DATE: DECEMBER 28, 2012
TO: U.S. DEALERS
SUBJECT: RECALL R12VT DRAG LINK CASTLE NUT TORQUE

Drag Link Castle Nut Torque

Models Affected: Certain 2013 Model Year Blue Bird Visions

Fig. 1

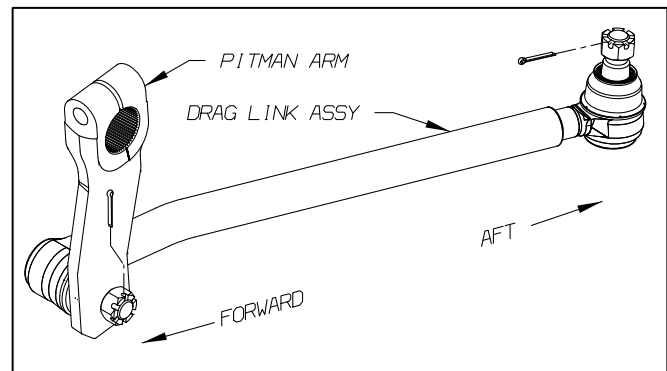
1. Park bus on a level surface, apply parking brake, switch engine off, remove ignition key and chock wheels.
2. Remove cotter pin from ball stud on forward (pitman arm) end of drag link. (Fig. 1)
3. Torque castle nut on drag link ball stud to 160-170 ft-lbs.
4. Re-install cotter pin. If castle nut slot for cotter pin does not line up with through hole in ball stud, tighten castle nut until next slot aligns with through hole. Install cotter pin & bend-over pin tails.
5. Remove cotter pin from ball stud on aft (steer arm) end of drag link. (Fig. 1)
6. Torque castle nut on drag link ball stud to 160- 170 ft-lbs to fully seat ball stud in steer arm.
7. Loosen aft castle nut approximately 6-8 turns.

WARNING: Do NOT loosen castle nut to line up slot with through hole in ball stud. Always tighten castle nut to align slot with through hole.

Fig. 4

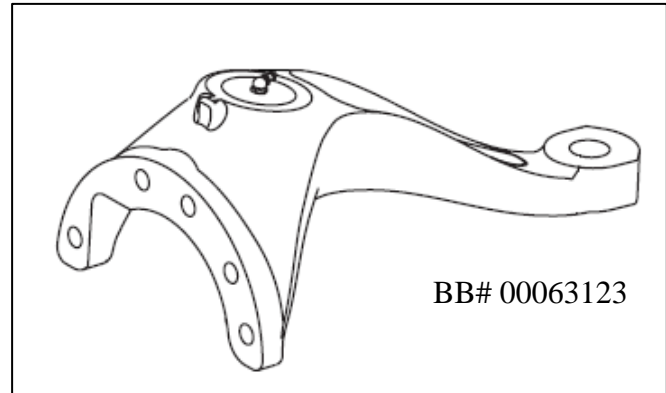
13. Replace axle mounted steer arm, BB# 00063123 (upper steering knuckle) per procedure outlined in BBCV service manual (Front Axle & Suspension, Appendix 1 of BBCV Vision Service Manual, Volume 1).

NOTE: Steer arm (Fig. 4) will come complete with kingpin bushing installed and reamed to correct size. Skip steps in service manual that detail KINGPIN MEASUREMENT, KINGPIN BUSHING REMOVAL, STEERING KNUCKLE BORE MEASUREMENT, KINGPIN BUSHING INSTALLATION, KINGPIN BUSHING REAMING, KINGPIN SEAL INSTALLATION.

14. Re-insert drag link ball stud into newly installed steering arm.
15. Torque castle nut on drag link ball stud to 160-170 ft-lbs.
16. Re-install cotter pin. If castle nut slot for cotter pin does not line up with through hole in ball stud, tighten castle nut until next slot aligns with through hole. Install cotter pin & bend-over pin tails. This completes the corrective action.
